DELEGATED APPLICATION REPORT

Address: 1-15 (odd) Queen Victoria Street & 145-148 Friar Street, Reading, RG1 1SY

Application No's: a) PL/25/1114 (NMA) b) PL/25/1106 (Variation to a listed building consent)

Proposal: a) Non-material amendments to permission PL/24/0422 (granted on 25/07/2024 for variation of conditions 2, 3, 4, 7, 21, 23, 25, 26, 27, 28, 31, 32, 33, 34, 38, 39, 40, 41, 42, 43, 44 & 48 and removal of conditions 29 & 30 of permission 221232 [dated 24/05/23 for various demolition works and redevelopment for reconfigured basement/ground floor uses, apart-hotel, various extensions and new-build elements, public courtyard and associated works], including reconfiguration of 5-15 (Odd) Queen Victoria St from 6 to 3 units at basement /ground floor level and rear dormer alterations at 3rd floor level, increase in rooms and provision of apart-hotel entrance on Queen Victoria St, remodelling of the extent of new-build elements at 145-146 Friar St, together with dormer and roof level changes, and various other associated works) to alter the wording of conditions 2, 4, 31, 32, 33, 38, 39, 40, 43 and 44 to reflect changes to the referenced plans, alter the trigger point for condi

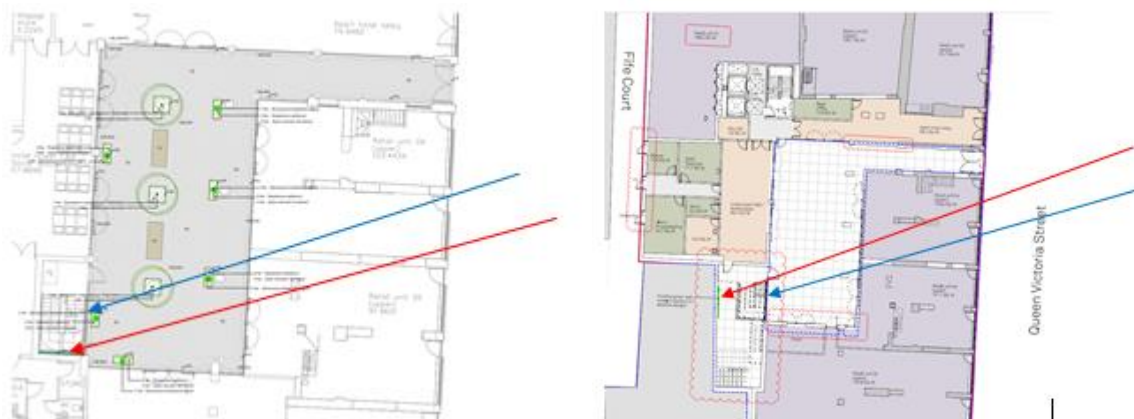
- **Reduction in size of plant areas to roof 1-15 QVS** – I find proposed enclosures not modest, compared with the existing roof forms of the listed building; they would be unusual additions. They are not ideal, but I am convinced that they would not be visible. Although for heritage assets, ‘visibility’ is just one aspect of the proposed development, I think they would not dominate or compete with the roof of the listed building. So, no objection.

3.3 Following the submission of more information / responses to the original comments, the Conservation Officer confirmed that these addressed the original queries raised, so no objection was raised to the proposals.

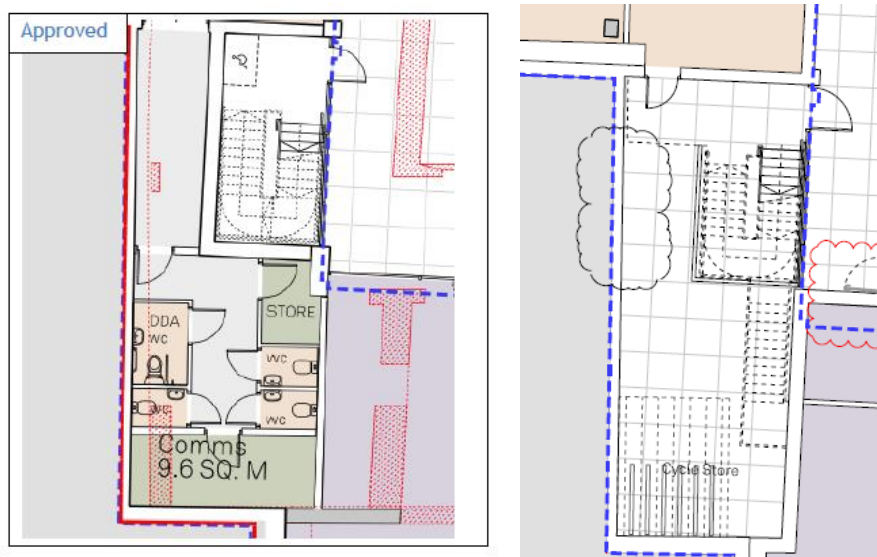
- Reduction in footprint of built form to the rear of 146 Friar Street from floorspace associated with the apart-hotel to create additional external space, adjacent to the

9.3 Officers consider that there are no overriding concerns with this proposed change. Although it will reduce the floorspace associated with the apart-hotel, these supporting facilities are incorporated elsewhere and hence will not impinge on the functioning of the future use. Moreover, this has come about following discussions with an intended occupier. Transport officers are satisfied with the cycle parking, as shown.

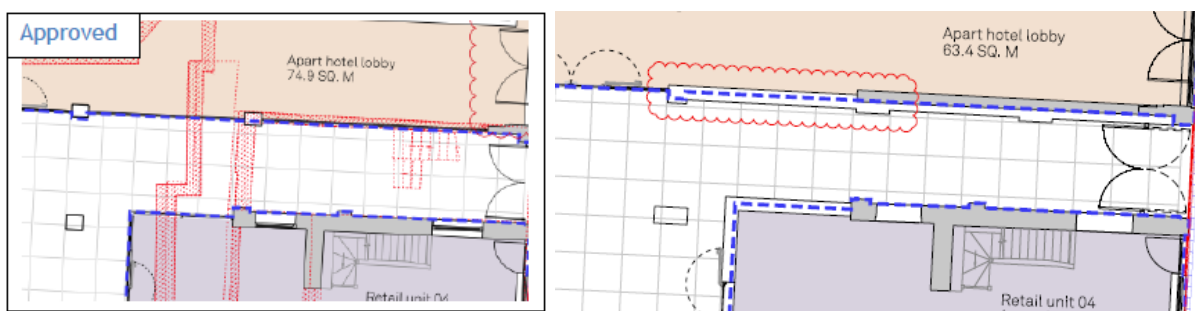
1.16 Building Regulations: below shows the ground floor changes been the approved and proposed changes to the means of escape from the courtyard to the QVS - a protected passage is required to meet Building Regulations as this is a protected means of escape. The direction of door opening has been changed to also open out.

9.5 Transport officers raise no issues with what is accepted to be a minor change to the approved scheme. It is acknowledged that the recess could create opportunities for rough sleeping or anti-

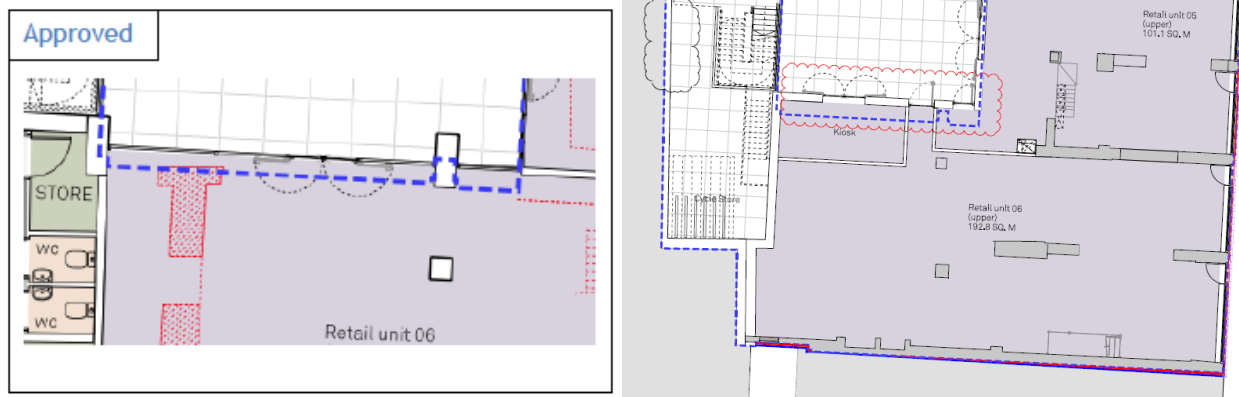
social behaviour (in comparison with being flush with the street), but the anticipated management of the space/area will seek to ensure that such risks are minimised.

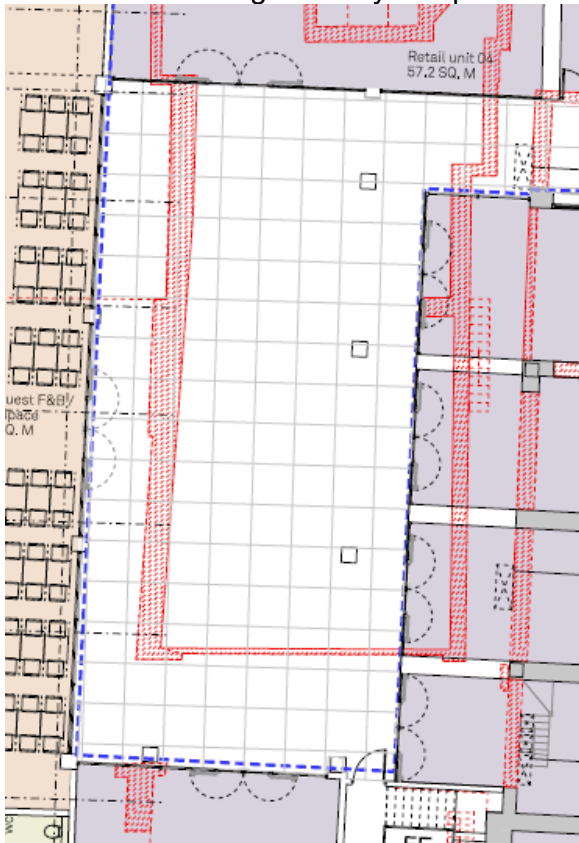
- 1.17 Retail Kiosk: a pop-up Retail Kiosk is proposed in Unit 06 that would be associated with the aparthotel and servicing the courtyard, this would operate in Class E and therefore not result in a material change in use nor reduction in floor area.

9.7 This proposed change effectively introduces a separate unit fronting the inner courtyard, which is generally welcomed in helping make the space a vibrant / well-used area. At the same time, it is not considered to unduly compromise the attractiveness of unit 06, whose primary frontage remains onto Queen Victoria Street. As per existing conditions, the unit of the created unit would be within Class E (a-f) and be required to adhere to other existing conditions in terms of its use

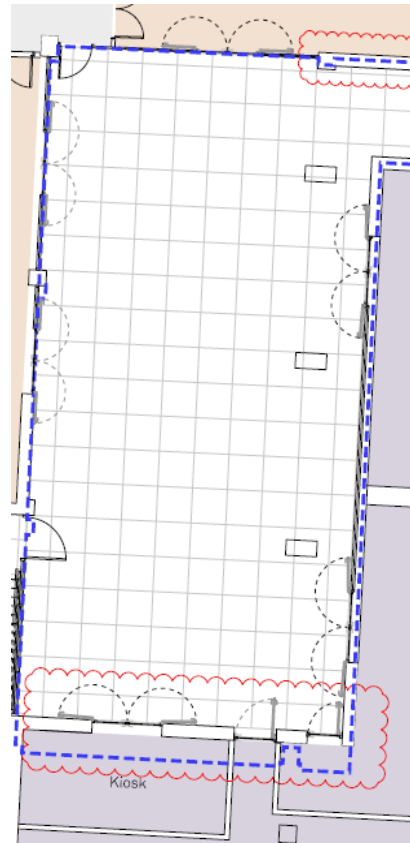
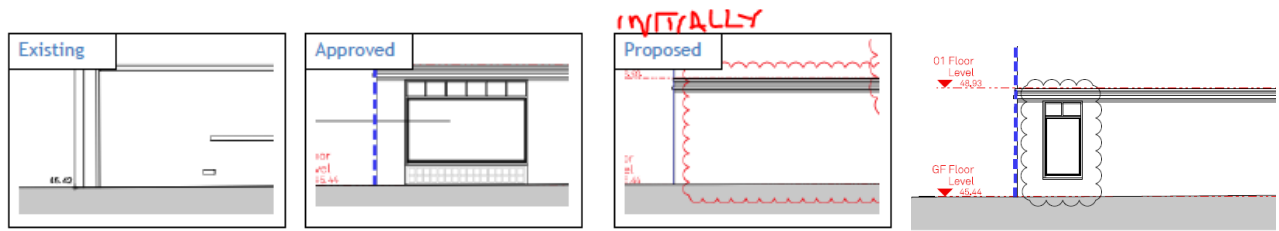
9.8 This change, as shown below, is accepted as a non-material amendment to the originally approved scheme, with no safety concerns arising owing to the doors opening out into an enclosed / managed courtyard space.

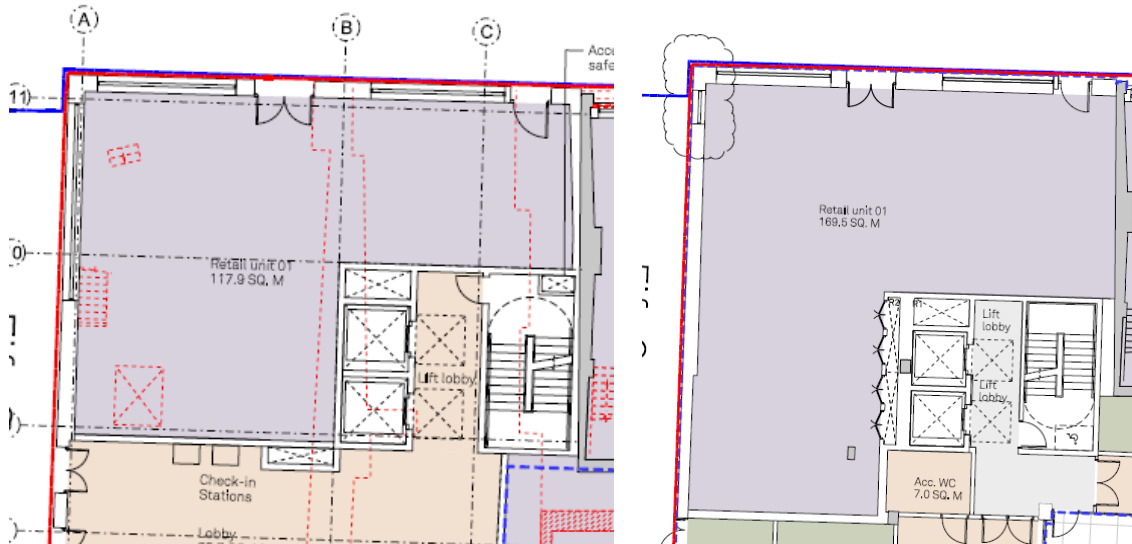
- 9.11 The applicant considered this and amended the proposal to provide a window at this point, albeit one which is reduced in width in comparison with the originally approved window – see above and below. The amended window is considered suitable and appropriate in the context of this non-material amendment application. The slight change in the unit size is not

considered to impact on the attractiveness of the space for future potential occupiers, so no concerns are raised.

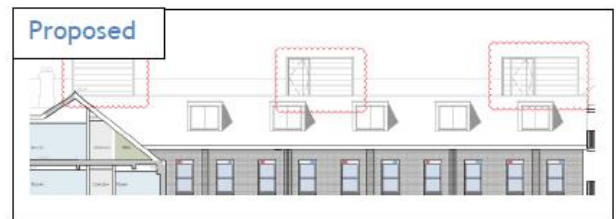
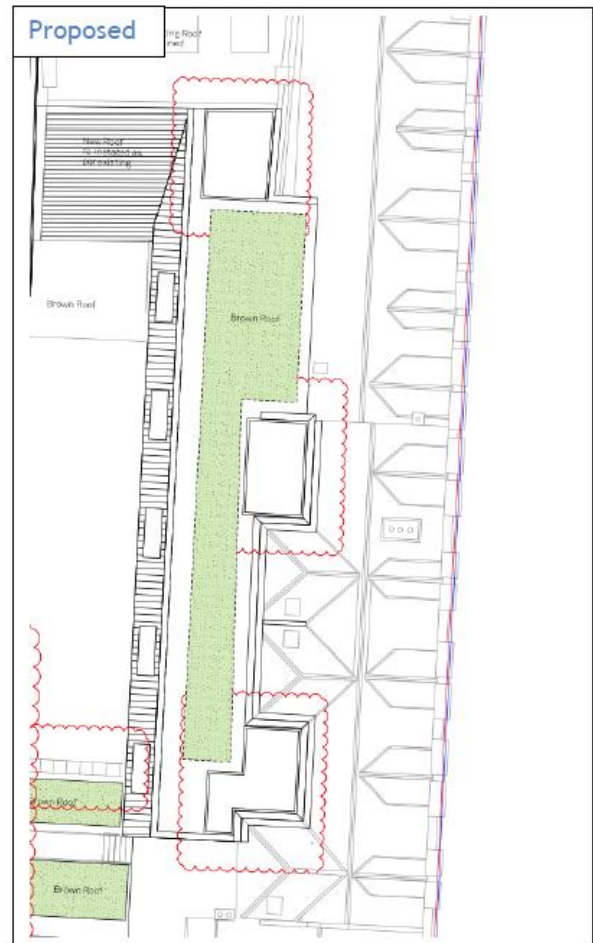
- 1.19 **Fenestration:** the Operator of the aparthotel has proposed some minor internal changes that has an impact on fenestration to the side elevation.

9.13 The change in location of ground floor doors is welcomed, as they now align with those on the upper floors. Other changes, such as the provision of intake (blue) and extract (red) bricks and reduction in the parapet height is discussed separately below.

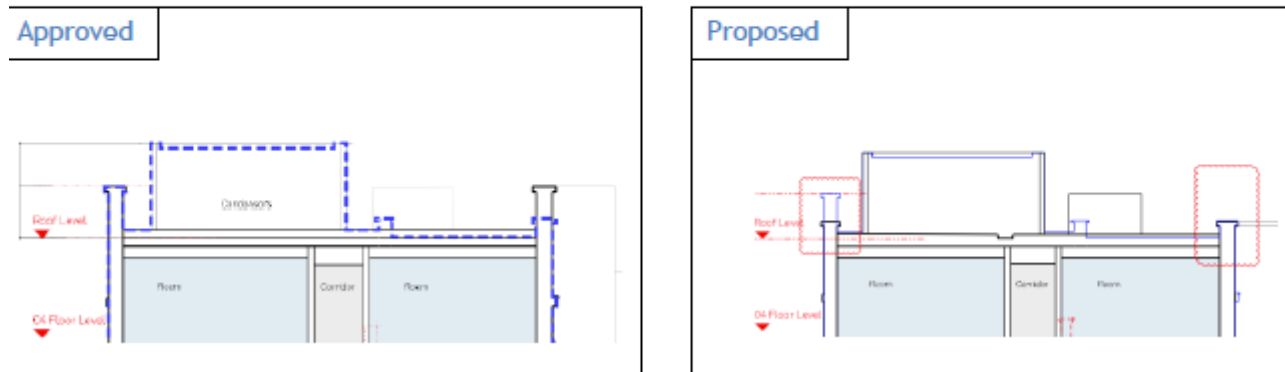
1.26 Plant: the approved scheme proposed a plant zone has already been reduced, the hatched orange area was omitted by planning permission ref: 221232. Full design development has confirmed the lift overrun, plant for Unit 2 and access hatch. The main plant zone is confirmed. A benefit is a the area of PV panels proposed can now be confirmed and detailed.

9.20 Officers are satisfied that these changes are both satisfactory and non-material in the context of the original permission.
